1. THIS PROJECT INCLUDES THE DESIGN, INSTALLATION, AND REMODEL OF AN EXISTING ADDRESSABLE FIRE ALARM SYSTEM FOR THE REMODELED AREAS FOR THE ELEVATOR REHAB PROJECT OF THE EXISTING BUILDING AS SHOWN ON THESE PLANS PER NFPA 72 (2019 ed.), LOCAL BUILDING CODES, AND THE VA FIRE PROTECTION DESIGN MANUAL (SEVENTH ed.). ALL DEMOLITION AND DISPOSAL OF EXISTING SYSTEM COMPONENTS SHALL BE PERFORMED AS REQUIRED.

wing Title	Project Title	Project Title			
IRE ALARM 2		REFURBISH ELEVATORS AND REPLACE CONTROLS			
proved: Project Director	Location 2101 ELN	1 STREET		Drawing Number	
wner		FARGO, ND 58102			
	12.20.22	MAS	NB	Dwg. of

1 FLOOR PLAN - LIBERTY 1,2,3 PENTHOUSE - TYPICAL 1/4" = 1'-0"

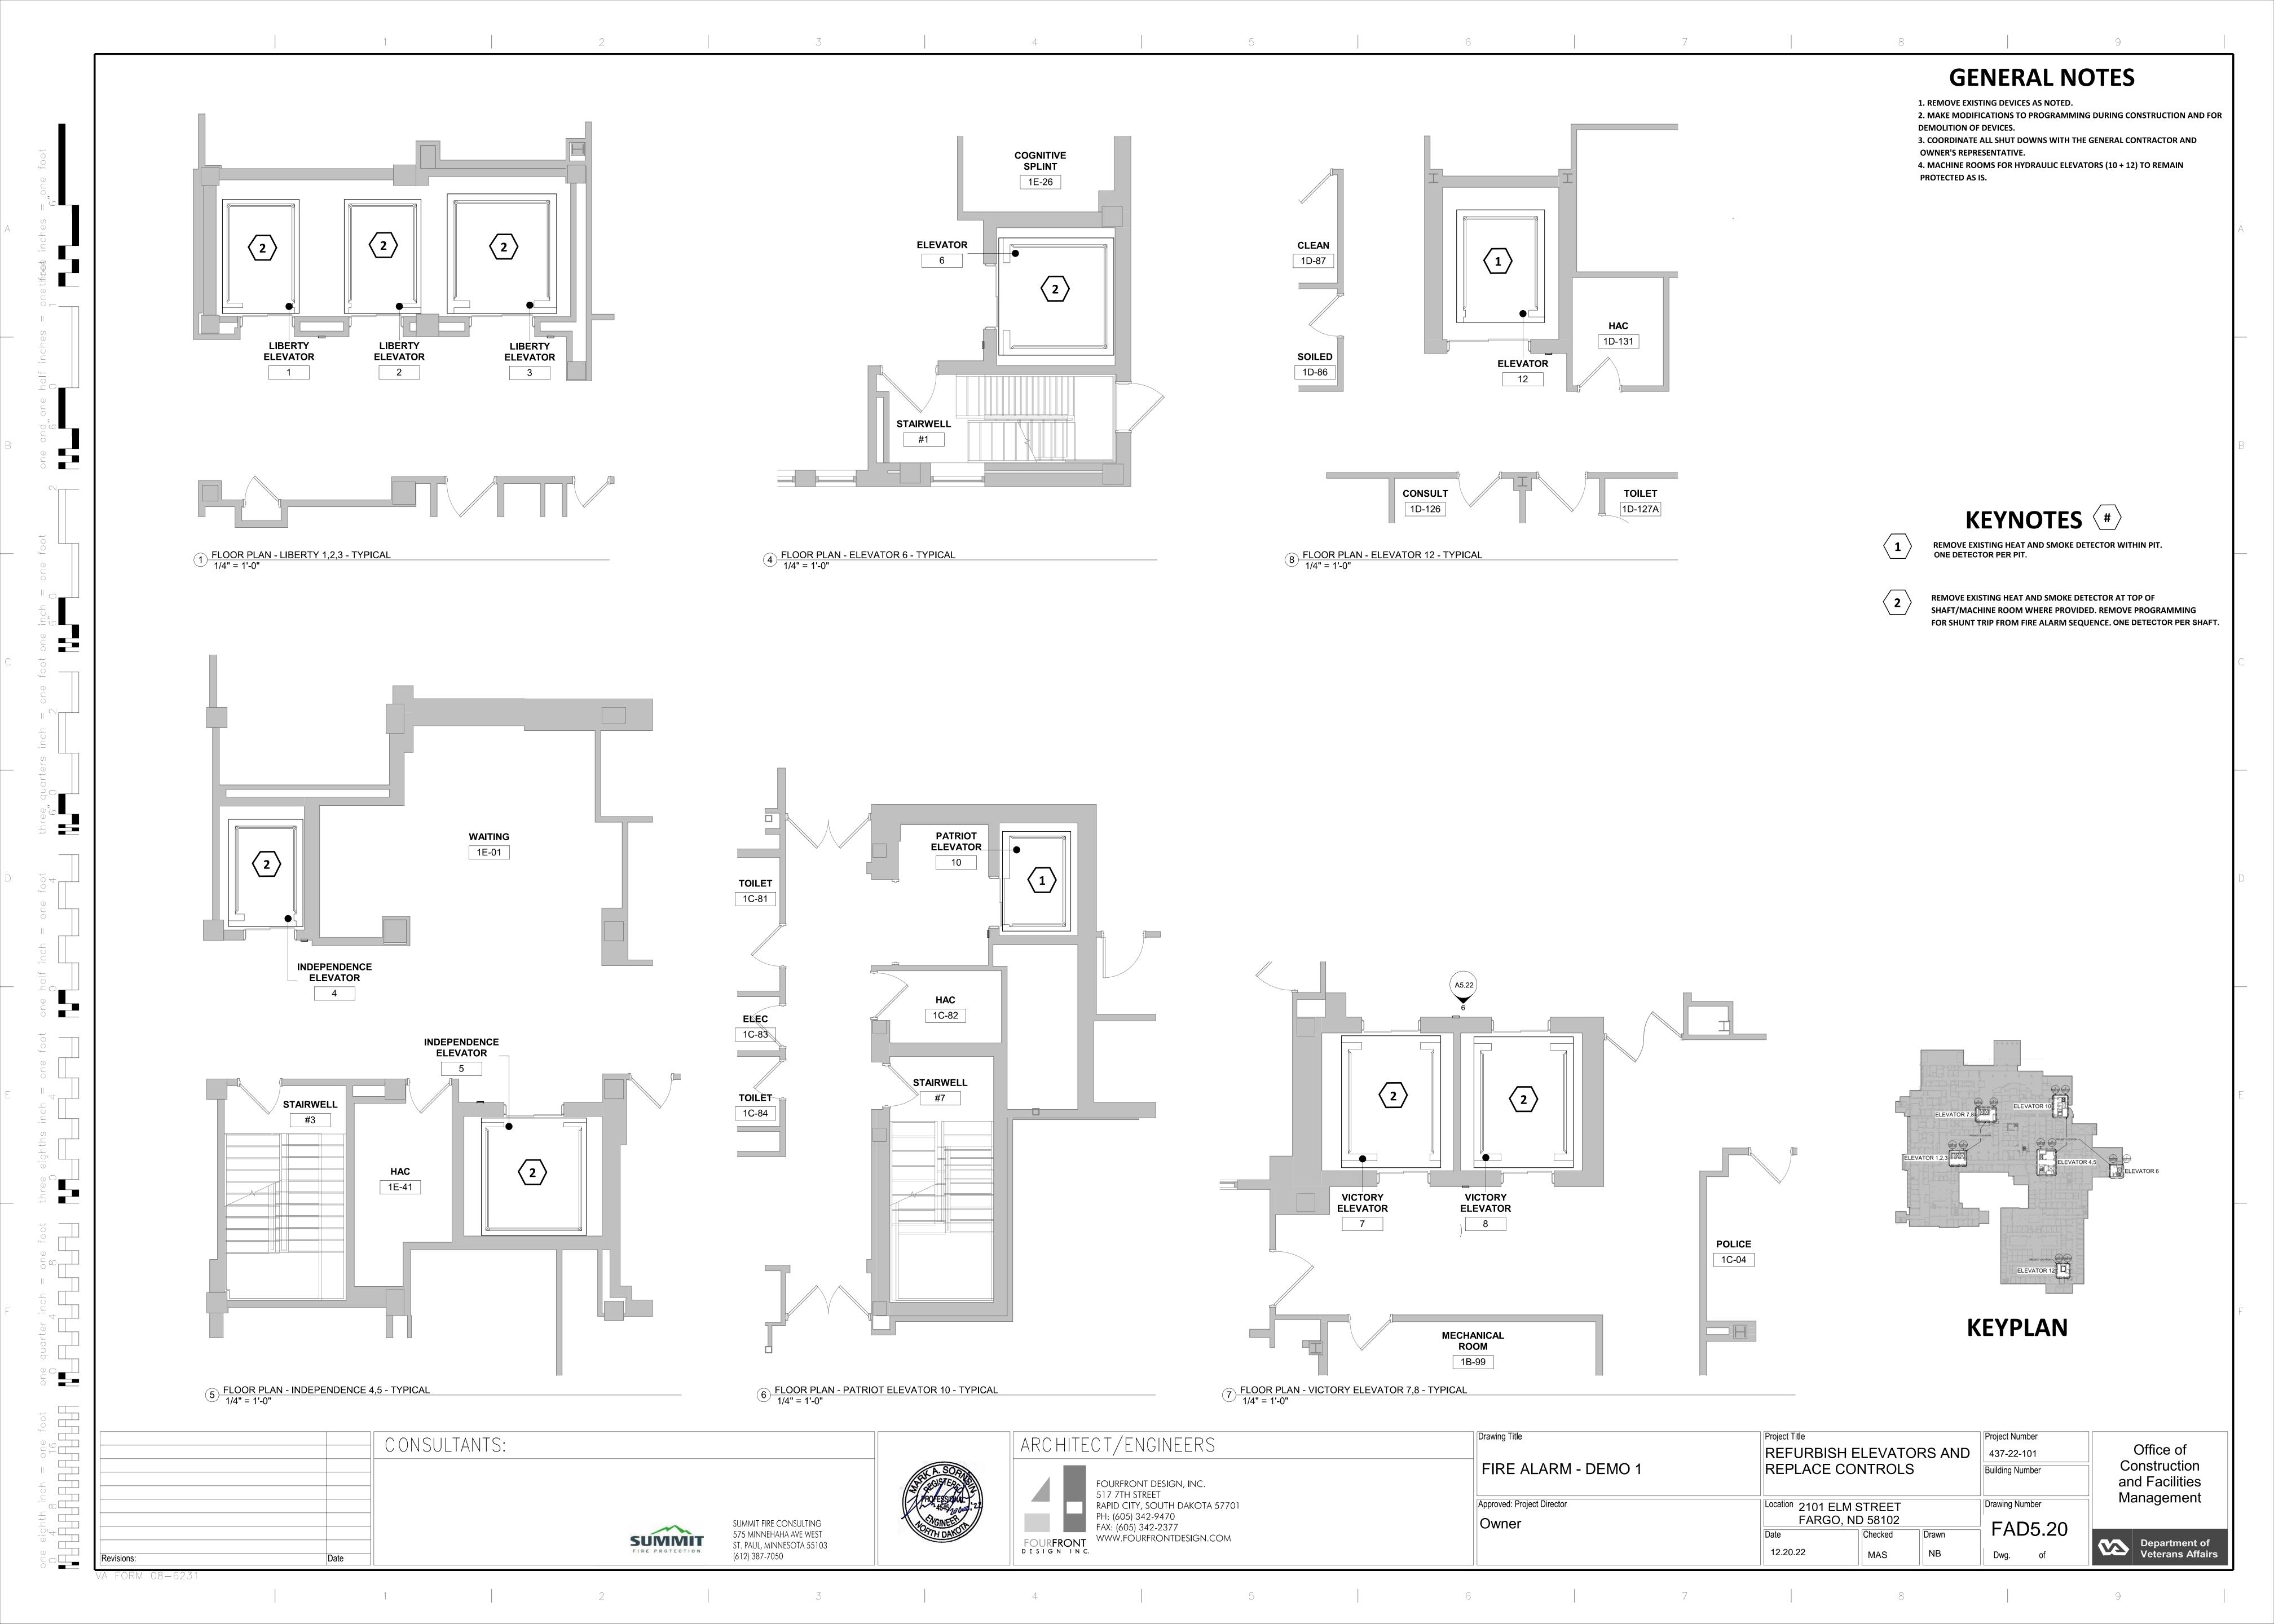
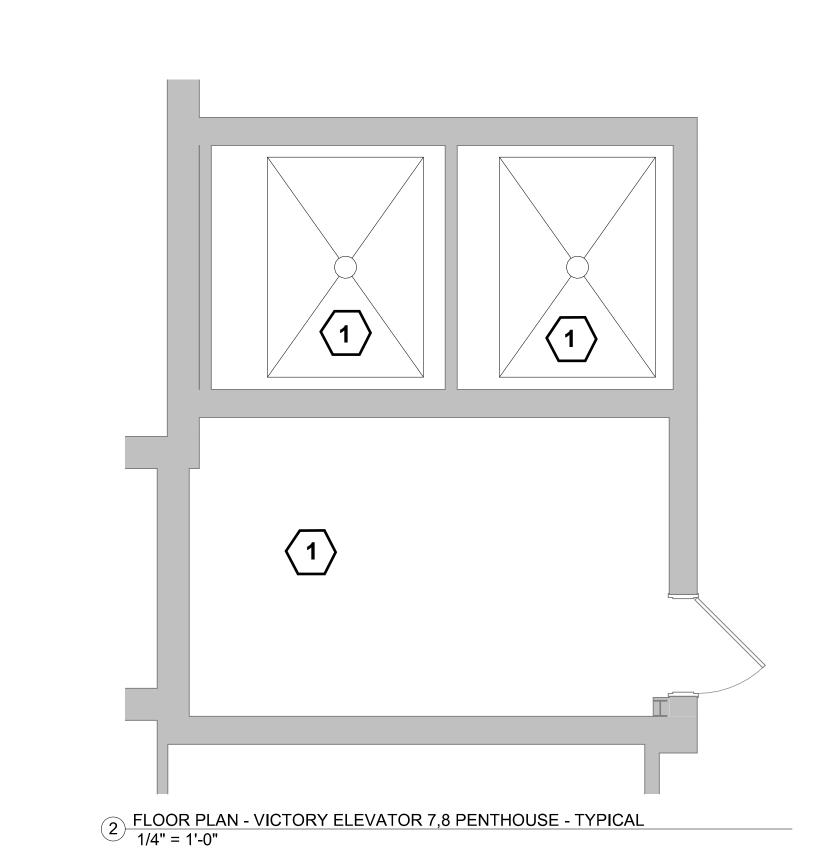
1. REMOVE EXISTING DEVICES AT TOP OF ELEVATOR SHAFT/PENTHOUSE.
2. MODIFY PROGRAMMING AS NOTED FOR MODIFICATIONS

REMOVE EXISTING HEAT AND SMOKE DETECTOR AT TOP OF SHAFT/MACHINE ROOM WHERE PROVIDED. REMOVE PROGRAMMING FOR SHUNT TRIP FROM FIRE ALARM SEQUENCE. ONE DETECTOR PER SHAFT.

1 FLOOR PLAN - LIBERTY 1,2,3 PENTHOUSE - TYPICAL 1/4" = 1'-0"

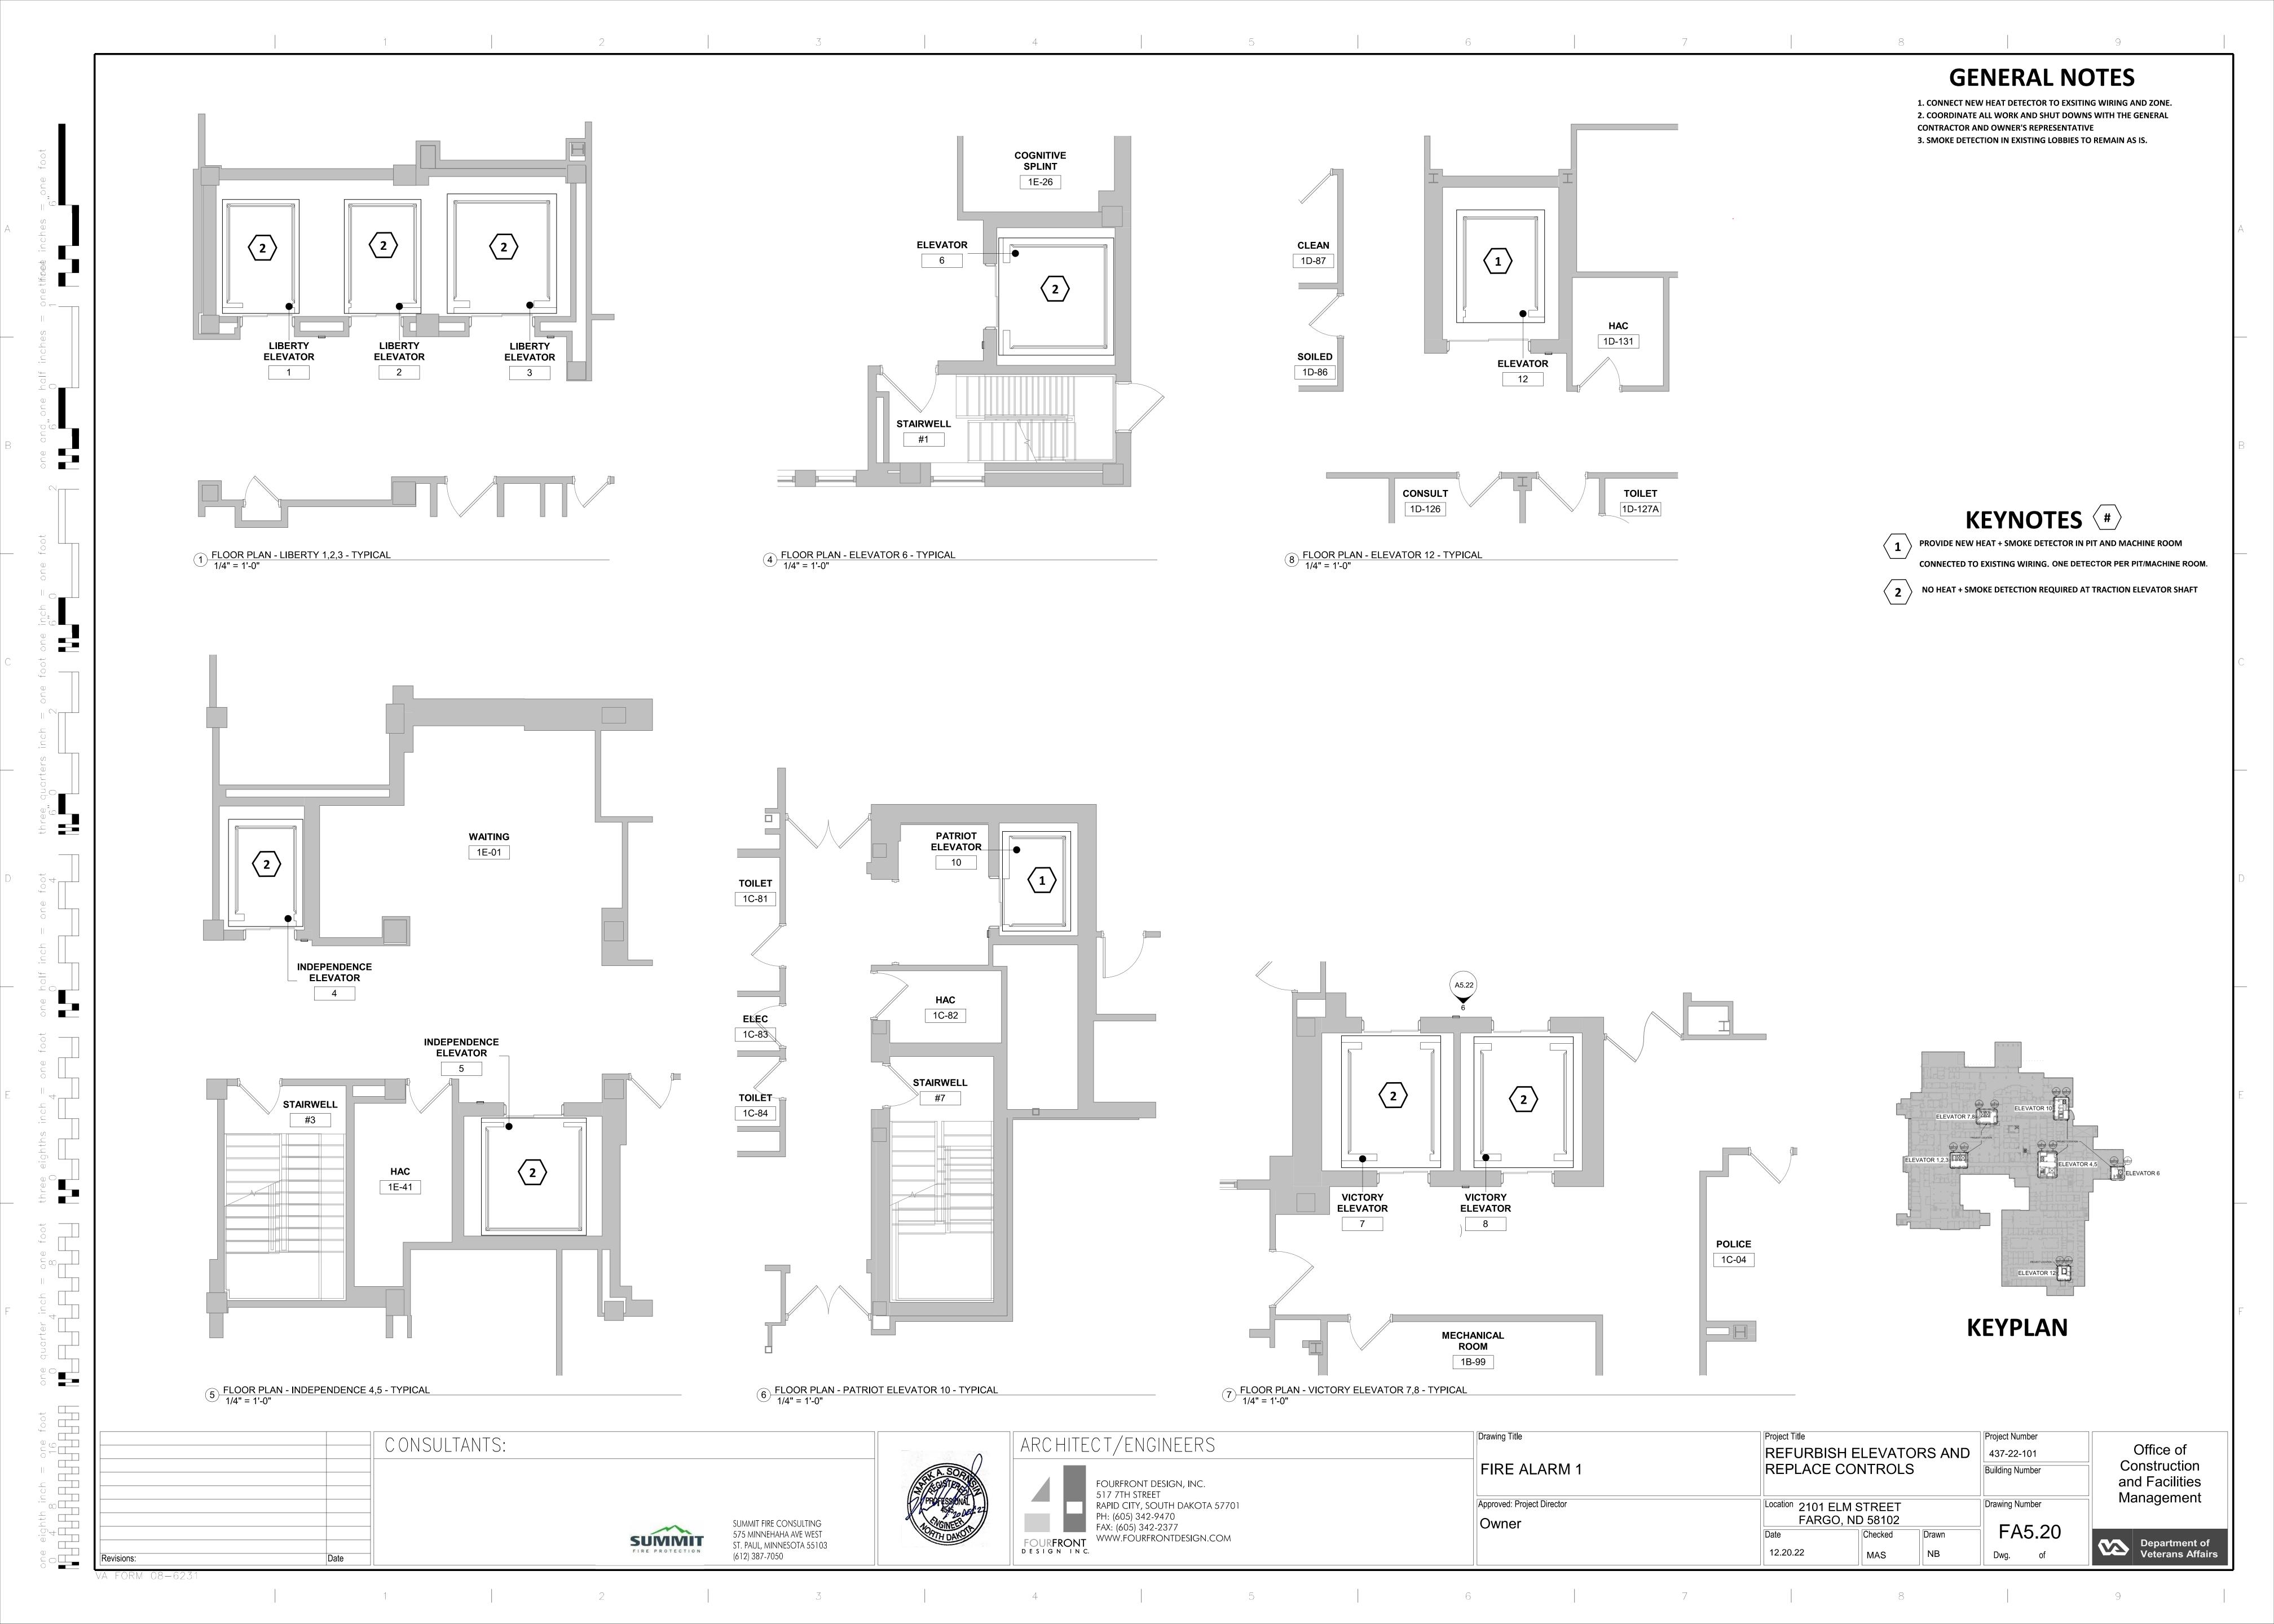
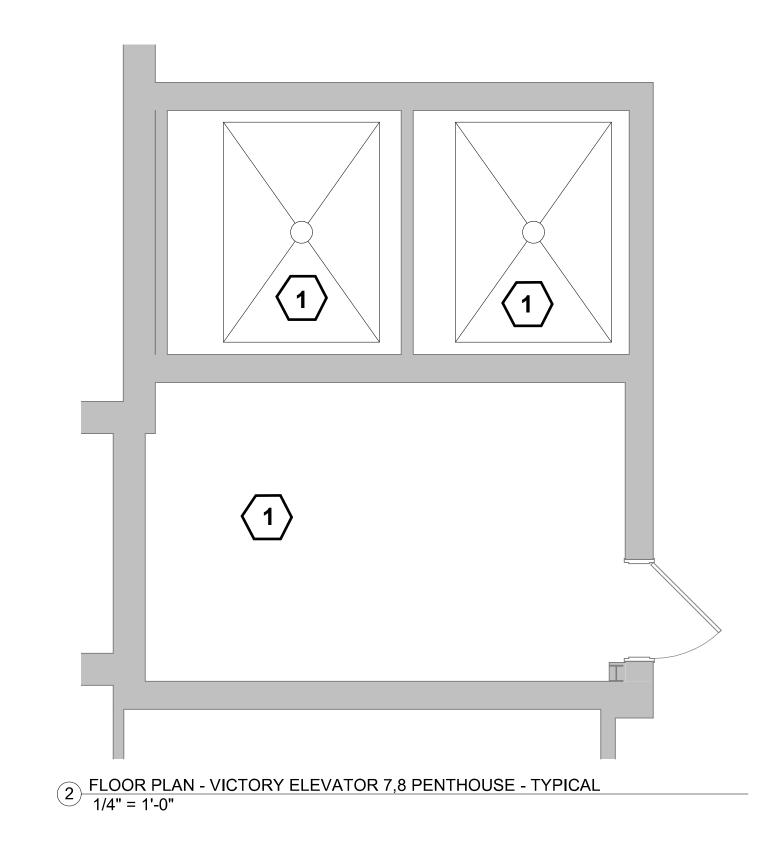
1. NO WORK IN PENTHOUSE OR TOP OF ELEVATOR SHAFT.

NO HEAT + SMOKE DETECTION REQUIRED AT TRACTION ELEVATOR SHAFT
